**NRC/TN Meeting  
CoC 9302 MP197HB  
RAI Discussions  
January 14, 2010**

# RAIs for Discussion (non-proprietary-information)

# Impact Limiter Analysis - RAI 2-31 (Continued) Hourglass

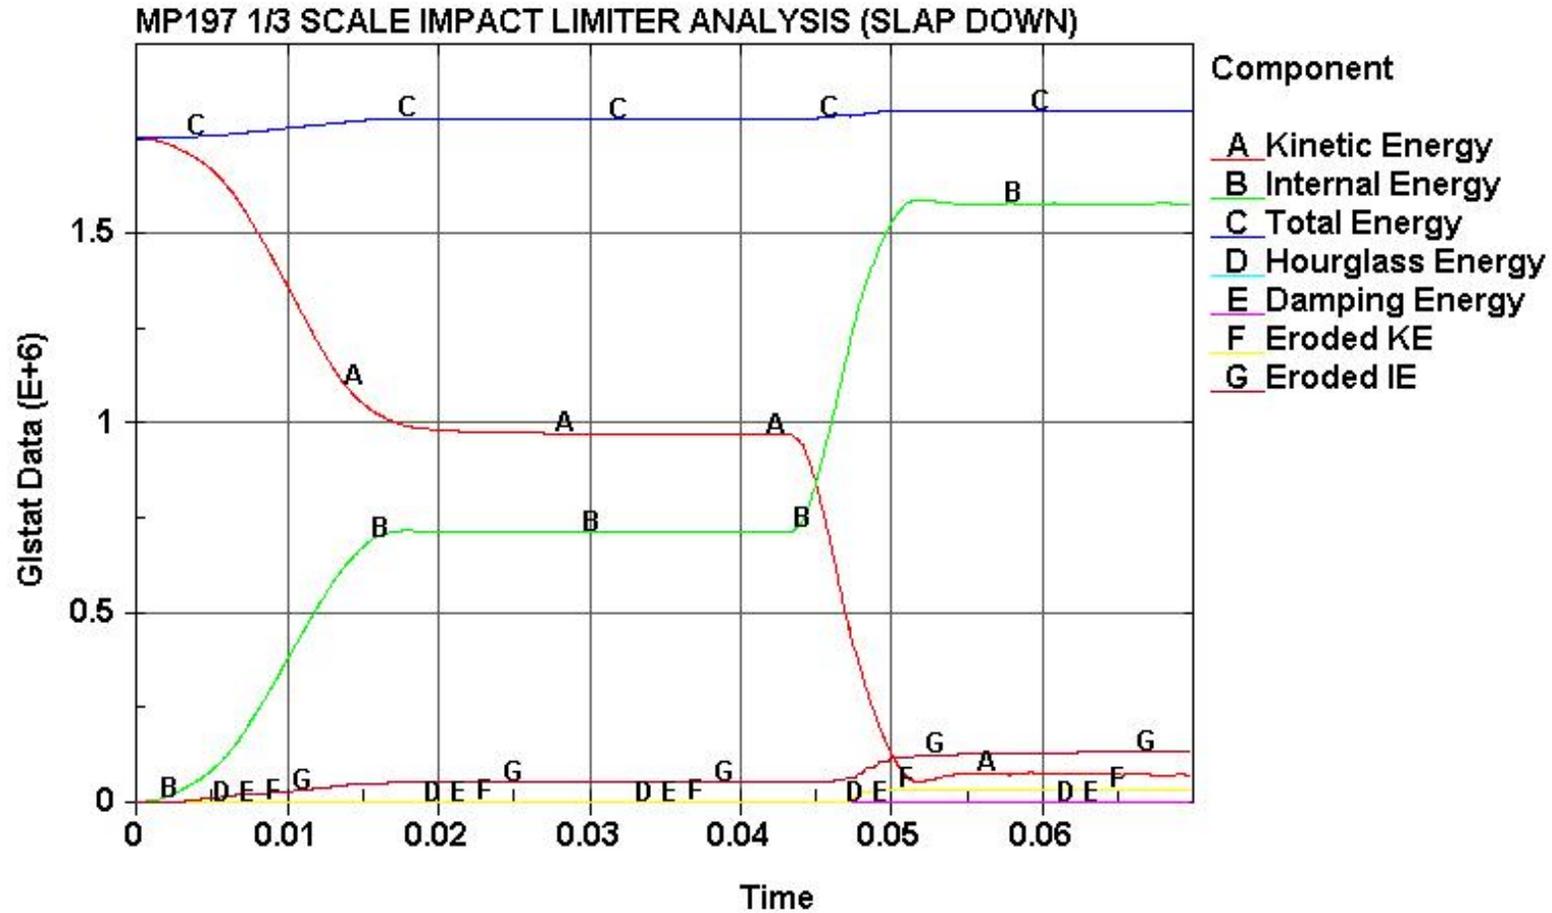
- Selectively reduced elements were chosen to reduce hourglassing
- The energy results for the 1/3 slapdown case show that the element distortions are a result of contact issues rather than hourglassing
- Contact definitions will be modified so as to resolve distortion
- Sensitivity Analysis will be performed to study the effect of selectively reduced elements vs constant stress elements

# Impact Limiter Analysis - RAI 2-36 and 2-37 Node Locations for Accelerations

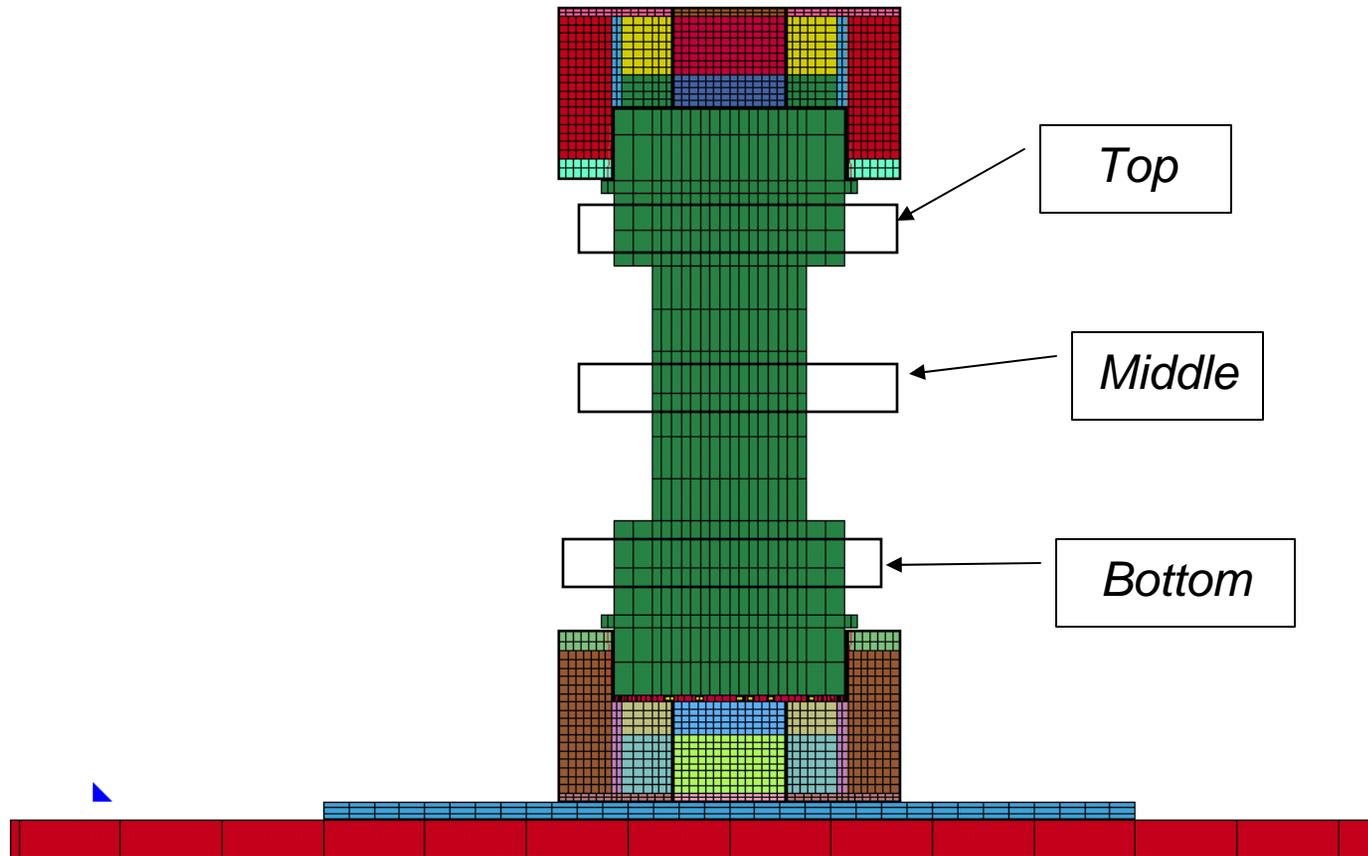
- The accelerations at all nodes in middle region were averaged for the end and side drop analysis and compared against the averaged accelerations from the accelerometer
- The accelerations at all of nodes in top and bottom regions were averaged for the slapdown analysis and compared against the averaged accelerations from the accelerometer at the top and bottom of the cask, respectively.
- The locations of the nodes for the top, middle, and bottom regions will be added to the SAR

# RAI 5-18 Response Function

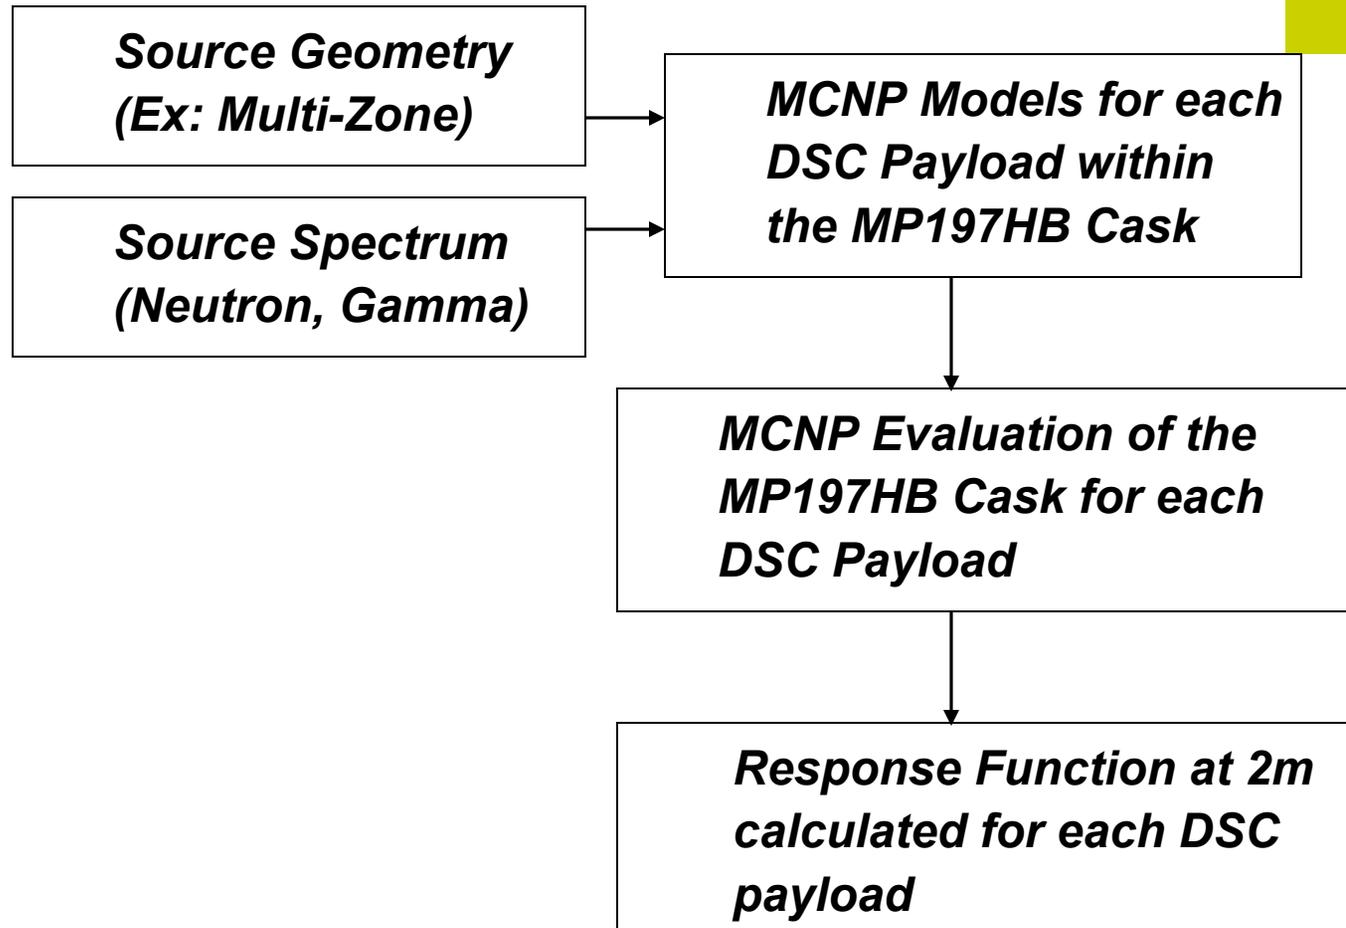
- A new Appendix will be added to Chapter A.5 to describe the Response Function Methodology
- Response Function is simply a dose rate ranking methodology and is based on MCNP results as a function of DSC Type and Energy Group
- Fuel Qualification Tables (FQTs) for shielding are generated using the Response Functions for each DSC to determine acceptable combinations of Burnup Enrichment and Cooling Time (BECT)
- The FQTs are designed such that any given BECT combination results in approximately the same dose rate at 2m under NCT
- The dose rates from Response Functions will be presented in the Appendix including the neutron and gamma contributions
- The dose rate calculated from Response Functions will also be compared to the MCNP results for selected BECT combinations
